<b>ORDINARY MEETING</b>	
<b>3 JUNE 2014</b>	<b>5.3</b>

OPERATIONAL WORKS (ROAD & DRAINAGE WORKS, STORMWATER, EARTHWORKS, WATER & SEWER INFRASTRUCTURE) – 36 MURPHY STREET, PORT DOUGLAS

Neil Beck: OP 84/2014 : 421367

<u>PROPOSAL:</u>	DEVELOPMENT PERMIT FOR OPERATIONAL WORKS (ROAD & DRAINAGE WORKS, STORMWATER, EARTHWORKS, WATER & SEWER INFRASTRUCTURE)
<u>APPLICANT:</u>	CARRON PROPERTIES PTY LTD (TTE) C/- PETER DUTAILLIS PO BOX 894 PORT DOUGLAS QLD 4877
<u>LOCATION OF SITE:</u>	36 MURPHY STREET PORT DOUGLAS QLD 4877
<u>PROPERTY:</u>	LOT 131 ON PTD2094
<u>LOCALITY:</u>	PORT DOUGLAS AND ENVIRONS
<u>PLANNING AREA:</u>	RESIDENTIAL 1
<u>PLANNING SCHEME:</u>	DOUGLAS SHIRE PLANNING SCHEME 2008
<u>REFERRAL AGENCIES:</u>	NONE APPLICABLE
<u>NUMBER OF SUBMITTERS:</u>	NOT APPLICABLE
<u>STATUTORY ASSESSMENT DEADLINE:</u>	19 JUNE 2014
<u>APPLICATION DATE:</u>	28 FEBRUARY 2014
<u>APPENDIX:</u>	<ol style="list-style-type: none"> <li>1. PLANS SUBMITTED WITH THE OPERATIONAL WORKS APPLICATION</li> <li>2. INFORMATION REQUEST &amp; RESPONSE</li> </ol>

**LOT 1 - ACCESS DRIVEWAY  
 -SET-OUT PLAN  
 -PROFILE PLAN**

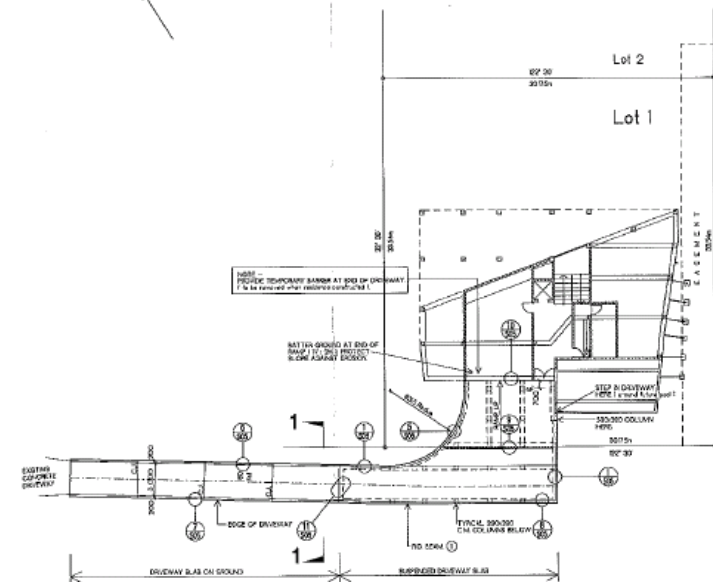
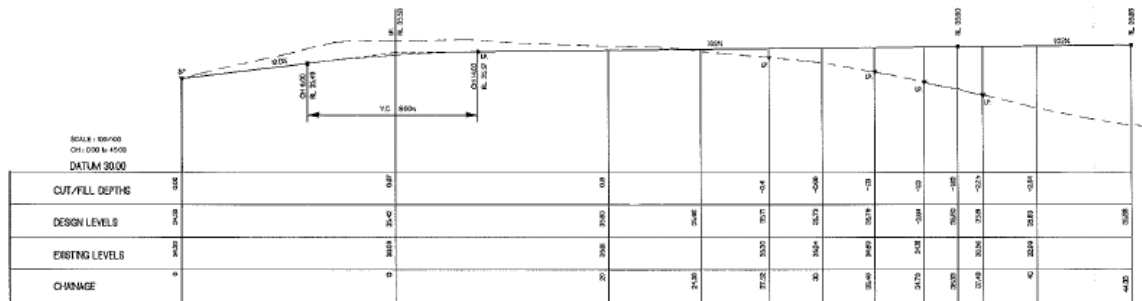
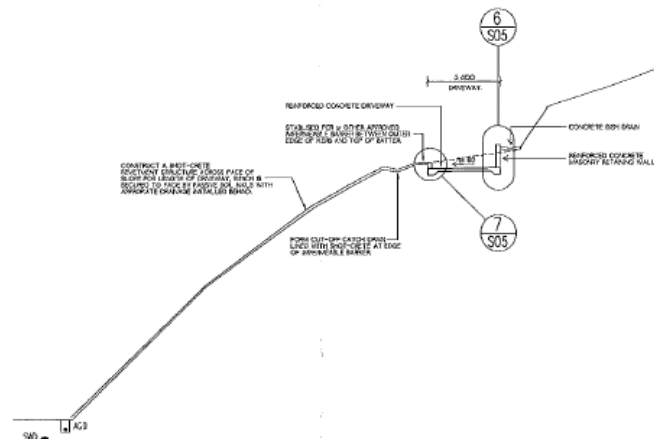
- (iii) The fettering of the ability for the road reserve to be used for its intended purpose, particularly the Owen Street road reserve;
- (iv) The lack of tenure over the road reserve area/s;
- (v) The elevated driveway proposed for Lot 1 Murphy Street is inconsistent with the driveway detail provided in the supporting material for the reconfiguration of the land. In addition, there is no structural detail or cross sections provided for this element or detail concerning the presence or need for of safety barriers. Please provide detail.

- (v) *The elevated driveway proposed for Lot 1 Murphy Street is inconsistent with the driveway detail provided in the supporting material for the reconfiguration of the land. In addition, there is no structural detail or cross sections provided for this element or detail concerning the presence or need for safety barriers. Please provide detail.*

- (v) The Approved Plan 4852 TP1 depicts the location of elevated driveway structure providing access to Lot 1. The drawing notes "proposed driveway reinforced concrete construction suspended on bored piers refer to civil documentation for all construction." Drawing 4852 C3 shows elevated concrete driveway on fill. Final design drawings have required the end of the access driveway to be raised to be consistent with proposed garage levels. This minimises fill earthworks and also reduces impact on natural drainage. The request for information notes that no structural details or cross sections are provided for the elevated driveway. Plan 12-3263 SO1 to SO5 detail 1 submitted with the operational works application shows amongst other things a proposed 1.05m high block wall to the edge of the driveway where it is elevated.

Drawing SO2A details longitudinal sections and references geotechnical works for batter stabilisation.

**SEWER LONG SECTION**  
SCALE AS SHOWN

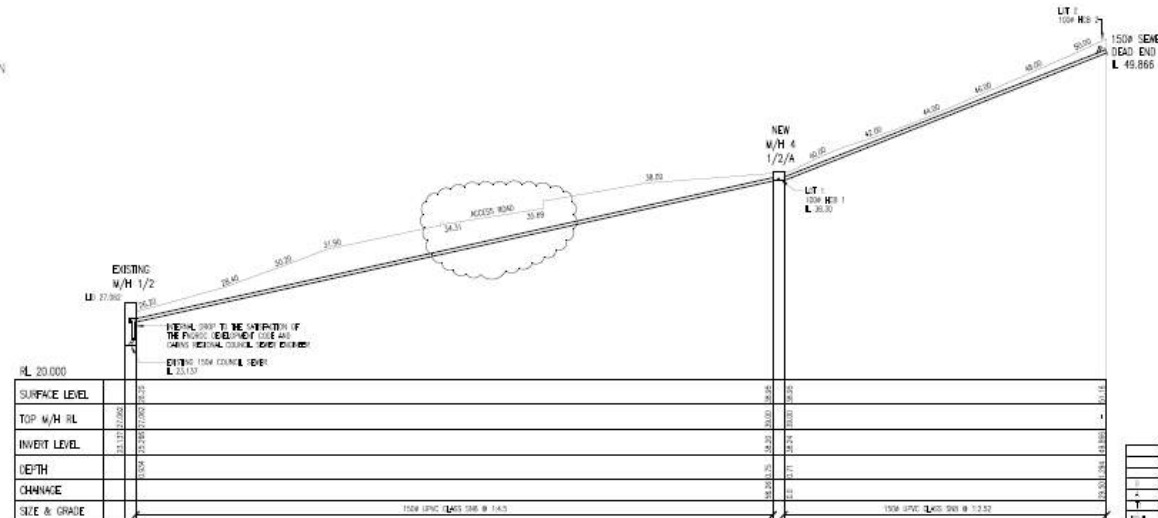
4. The plans by Gilboy Hydraulic Solutions indicate a relatively shallow cover to the top section of the sewer in Lot 1. Provide details of the cover to be provided and confirmation that the sewer will be constructed in accordance with the FNQROC Development Manual for the construction of sewers on steep slopes.

The sewer long section shown on drawing 111780/HS001/T1 does not appear to reflect the revised (cut in) driveway on Murphy Street. Please clarify and advise if this will impact on the sewer design.

4. *The plans by Gilboy Hydraulic Solutions indicate a relatively shallow cover to the top section of the sewer in Lot 1. Provide details of the cover to be provided and confirmation that the sewer will be constructed in accordance with the FNQROC Development Manual for the construction of sewers on steep slopes.*

*The sewer long section shown on drawing 111780/HS001/T1 does not appear to reflect the revised (cut in) driveway on Murphy Street. Please clarify and advise if this will impact on the sewer design.*

We note also that the driveway recut does not impact on reducing the cover of the sewer as it is 2.0m below the driveway at the shallowest point. We **enclose** an amended drawing to reflect the revised driveway section. **Attachment A** - Drawing # 111780/HS001/B.
